***MAJOR PROJECT ASSESSMENT
Myuna Colliery Mining Project***

Director-General's
Environmental Assessment Report
Section 75I of the
Environmental Planning and Assessment Act 1979

December 2011

Figure 5: Cross section, showing Zone A, Transition Area and Zone B

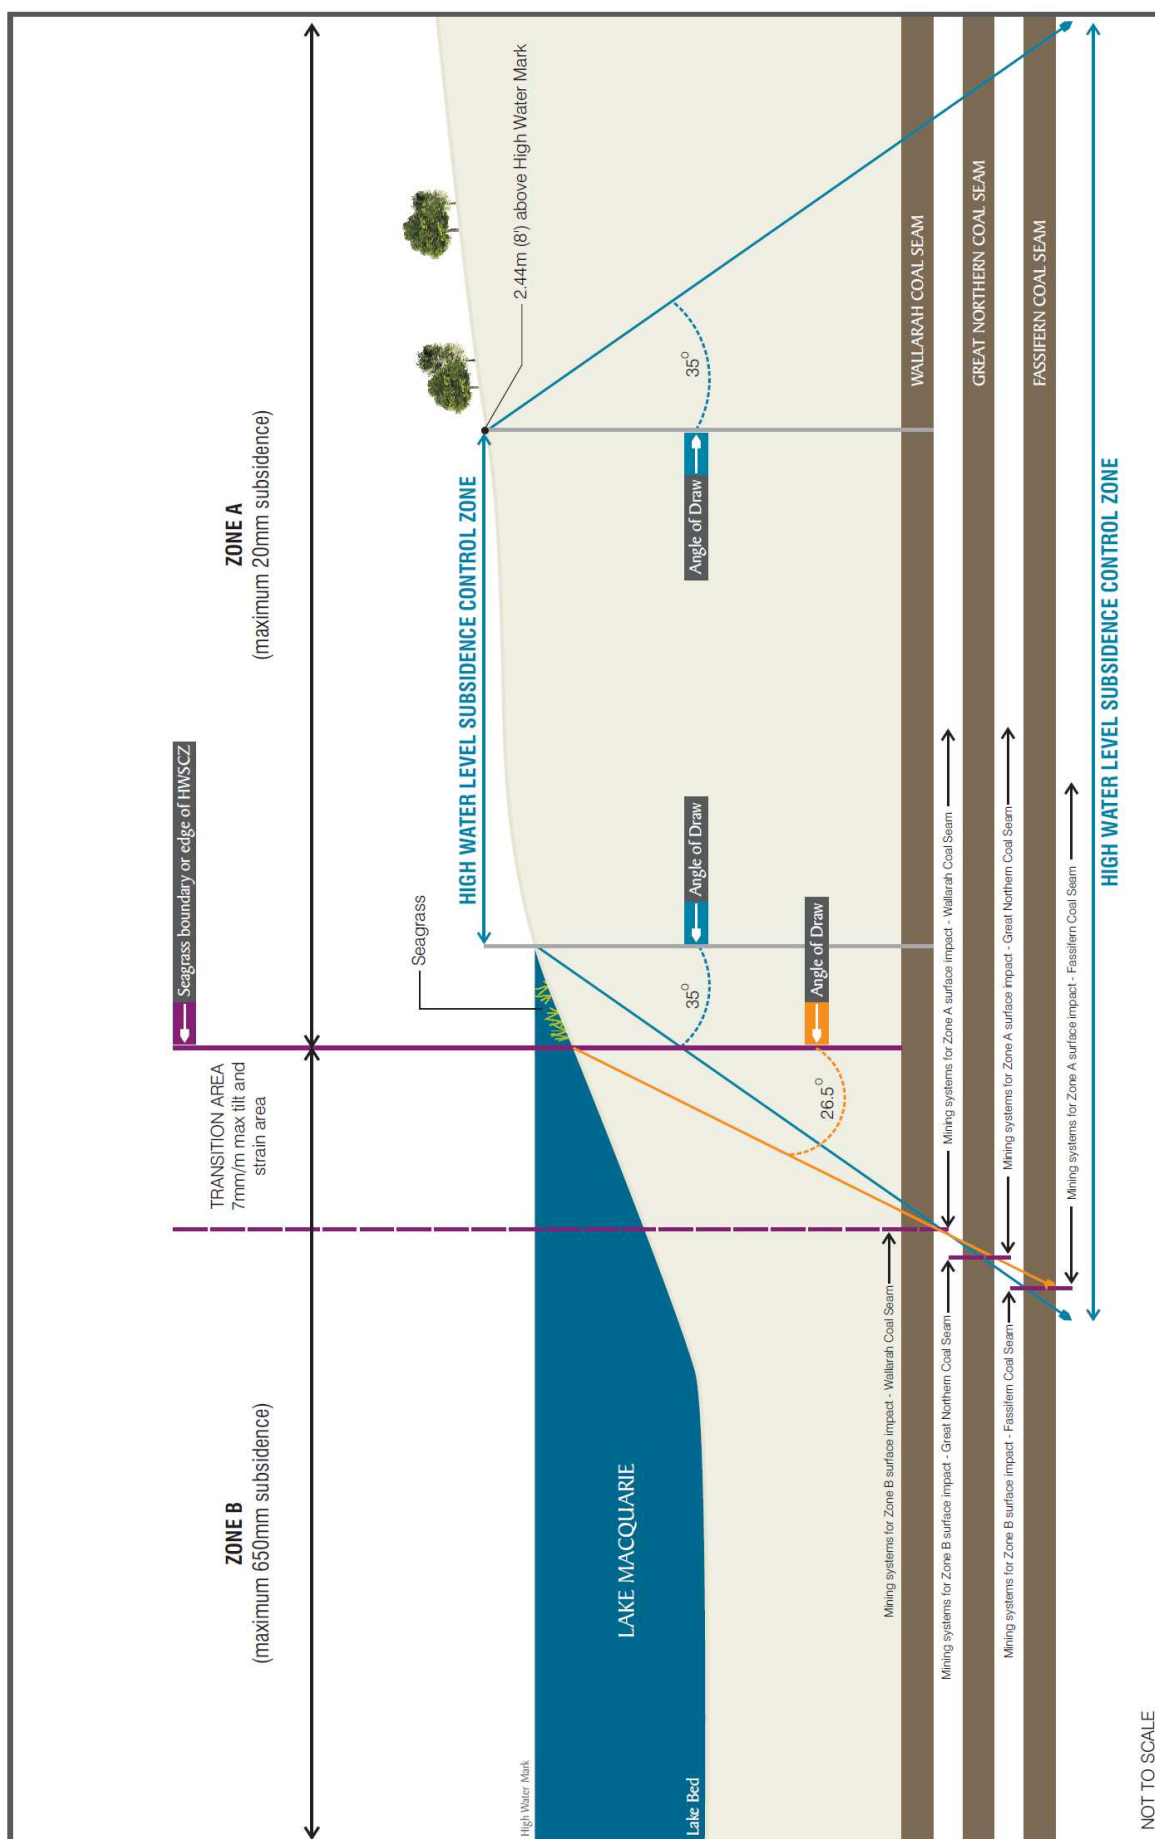
Because of the substantial difference in the proposed subsidence limits (ie 20 mm vs 650 mm), there must be a transitional area between Zones A and B. Centennial proposes that use of Zone B mining systems is limited by an angle of draw of either 26.5° from the deepest extent of any seagrass bed present, or by an angle of draw of 35° from the high-water mark of the Lake if no seagrass bed is present. This effectively provides a transitional area between Zones A and B. The mining methods proposed in Zones A & B within each coal seam are summarised in **Table 2** and displayed graphically in **Figure 5** below.

It should be noted that Centennial initially sought full pillar extraction within Zone B, as this method of extraction is currently permitted within its development consent area. However, as part of its response to submissions, Centennial revised its proposal to seek approval for partial pillar extraction only (as shown in **Table 2** and **Figure 5**). There is no longwall mining proposed for any part of the project.

The Seedsman report affirms that the design of the transition area would limit vertical subsidence at the boundary of Zone A to a maximum of 20 mm and limit maximum tilts and strains at this point to 7 mm/m. The proposed 26.5° angle of draw by which Zone B mining systems would be offset from the deepest extent of any seagrass bed present is predicted to provide seagrass beds with adequate protection from vertical subsidence, which may otherwise impact on matters such as the penetration of light through the water column. Seagrasses are further discussed in **Section 5.2**.
